February 11, 2020

Re: Baker Creek North PUD
Applicant's Supplemental Comments

Exhibit 1: SFD - 70 Driveway

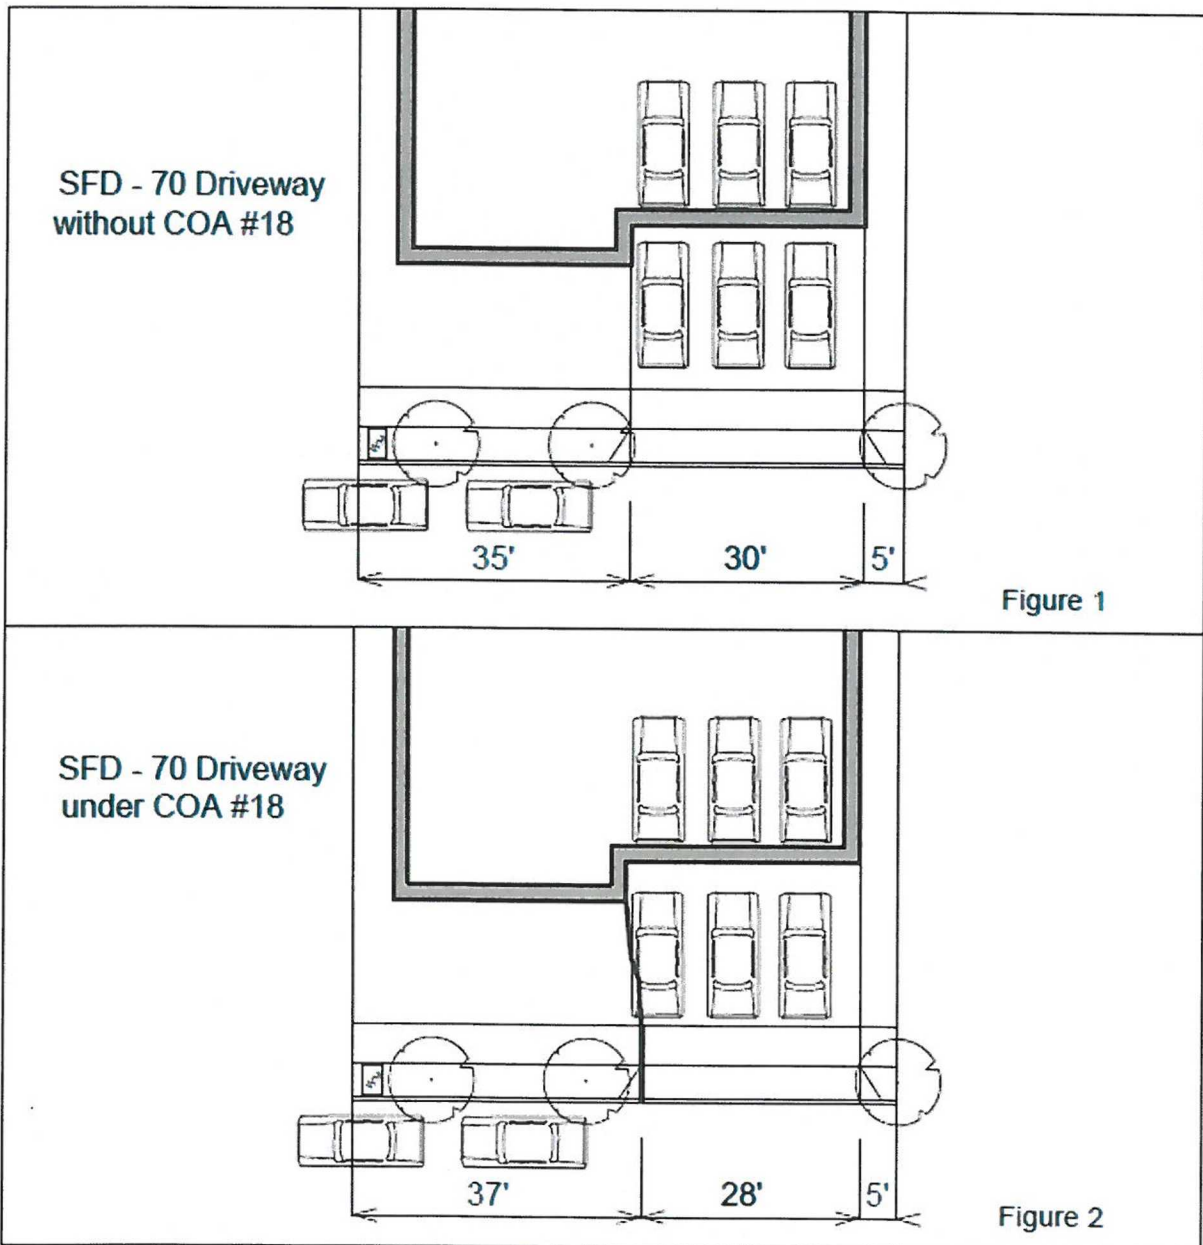
The Planning Commission's recommendation requires applicant to "neck down" driveway widths in the area between the sidewalk and the street 2-feet on SFD-70 lots to a maximum width of 28 feet, and 6-feet on SFD-60 lots to a maximum width of only 24 feet. Driveways that serve three-car garages require a minimum width of 30-feet to safely enter and exit garage doors. A 30-foot wide driveway also affords the area required for homeowners and their guests to safely negotiate around parked vehicles to access the home's front entry, garage, and side yard area.

Stafford included several drawings in its February 4, 2020 submittal to the Council (which are also included herein for easy reference) that visually demonstrate the direct impacts "necking down" driveway approach widths between the property line and the street will have on homeowners' abilities to fully utilize the private portion of the driveway area and to safely access the garage and home generally. As shown below and in Figures 2 and 3 of Exhibit 2, the requirement will negatively impact the usability of driveways and garages on SFD-70 lots, and it will make the third garage bays and off-street parking areas on SFD-60 lots extremely difficult to navigate for their intended purposes.

Exhibit 2: SFD - 60 Driveway

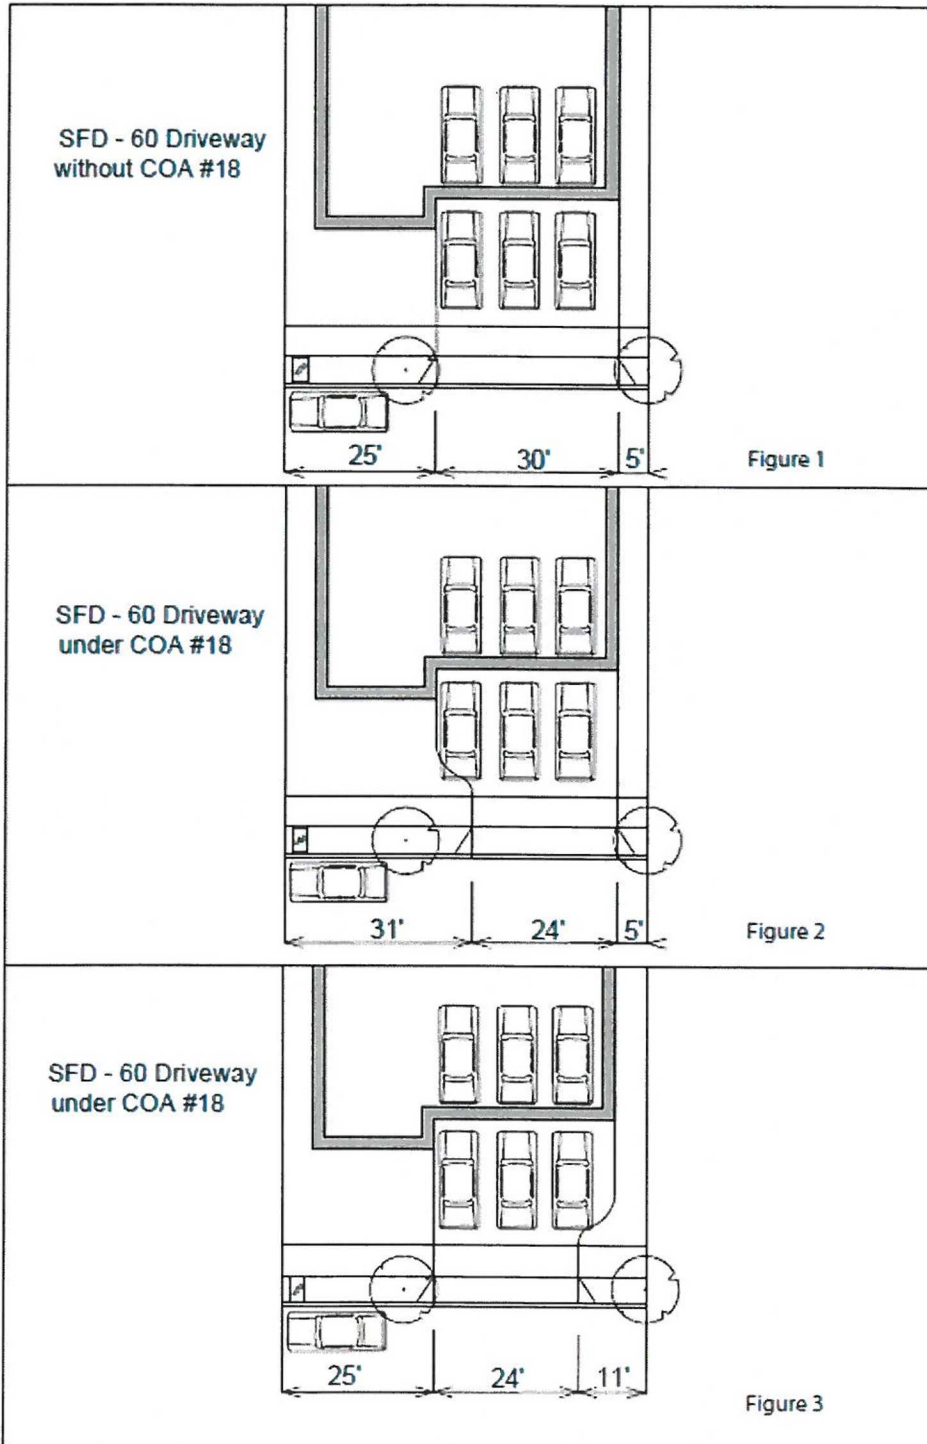
“Necked down” driveways are uncommon designs that are not frequently found in residential subdivisions in McMinnville or the surrounding area. Stafford expects that homeowners, and more likely their visitors and guests, will fail to recognize or anticipate the “necked down” areas and that they will drive over sidewalks, curbs, and landscaped areas to access the home’s garage and off-street parking areas, which will result in damage to driveway and sidewalk edges, curbs, and vegetation and irrigation installed in the planter strip areas.
